## Report to the Future Melbourne (Planning) Committee

Ministerial Referral: TPM-2015-29 183 – 189 A'Beckett Street Melbourne

## **PLANNING REPORT**

Application number: TPM-2015-29

Figure 3: 3D image of proposed tower as viewed from A'Beckett Street.

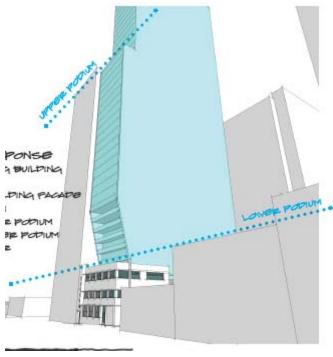
The proposal seeks to retain the existing façade of the heritage building on the north, east and west elevations to a length of approximately 14m. All other parts of the building including the roof is proposed to be demolished to allow for the construction of a 202m high tower (refer to figures 3 and 4 above).

The extent of demolition combined with the cumulative impact of the height and limited setbacks of the tower will have an unacceptable impact on the significance and character of the heritage building, and will have a dominating and overbearing presence above the heritage building.

Figure 5: Diagram showing the proposed setbacks of the tower.

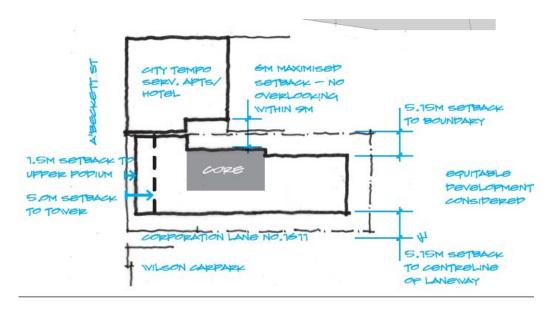
Above the staggering element which is proposed up to level 26, the tower will be setback 5m from this boundary. This does not comply with Clause 22.01 which requires towers above podium to be setback at least 10 metres from the street frontages.

The subject site adjoins potential future development sites to its rear and western side boundaries. The tower is proposed to be setback 5m from these boundaries. This is not supported for a 202m high tower which has apartments directly facing the boundaries.

The 5m setback for the current proposal does not allow for adequate tower separation, will result in unreasonable impact on the amenity of future apartments by loss of outlook and daylight and more importantly, will constrain future developments on the adjoining sites.

Figure 6: Typical floor layout of the proposed tower and neighbouring residential apartment building located at 175-181 A'Beckett Street. The red area shows the 202m high wall which will be constructed opposite the windows and balconies of the apartments of the existing apartment building.

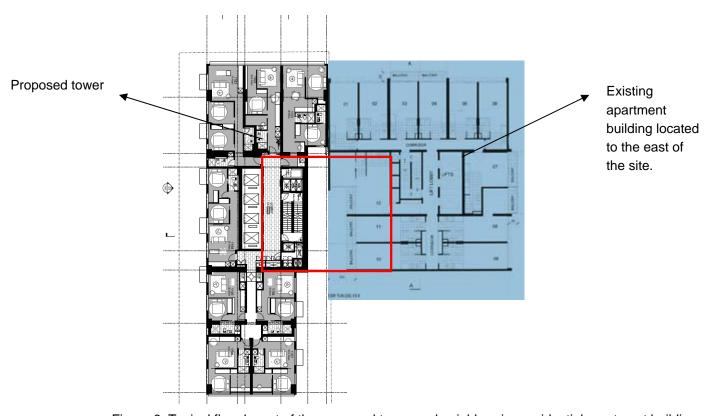
The site at 175-181 A'Beckett Street is currently occupied with a 29 storey residential building. This building contains apartments with habitable room windows setback 3m from the common boundary. There are balconies constructed within this 3m setback (refer to Figure 7). The proposed tower will be setback 6m from these habitable room windows and less from the balconies (Refer to Figure 6).

This side setback for a 202m high tower is not supported. It will result in excessive visual bulk, loss of daylight and inadequate outlook resulting in poor amenity outcome for both existing and future residents.
